Proposal for draft Supplement 12 to the 04 series of amendments to Regulation No. 44 (Child Restraint Systems)

The text reproduced below was prepared by the expert from Spain on behalf of the Technical Services Group (TSG) on Regulation No. 44. The modifications to the current text of Regulation are marked in bold for new or strikethrough for deleted characters.

Annex 23, amend to read:

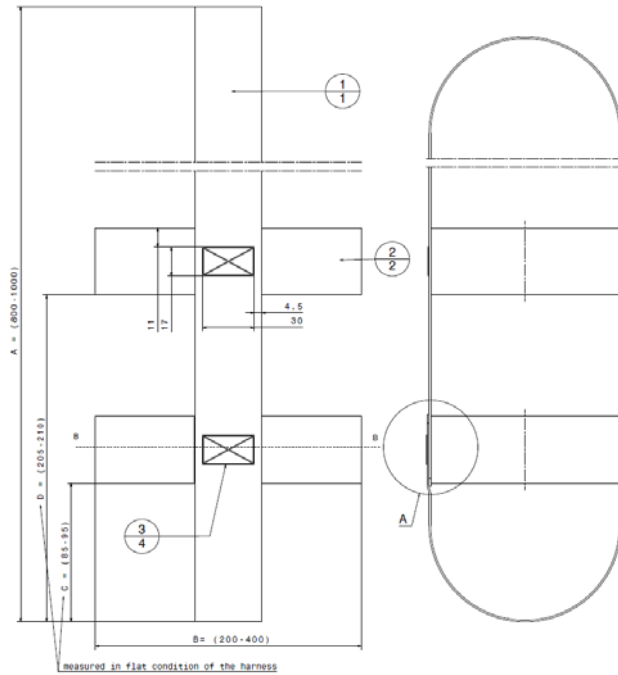
Load application device II

Proposal aligns requirements set in 7.1.3.1 to test methods, 8.1.2.4 where it is already stated; modification in 8.1.2.3 add tolerances to better define test method. Amendment in Annex 23, specifies how to measured dimensions C and D.
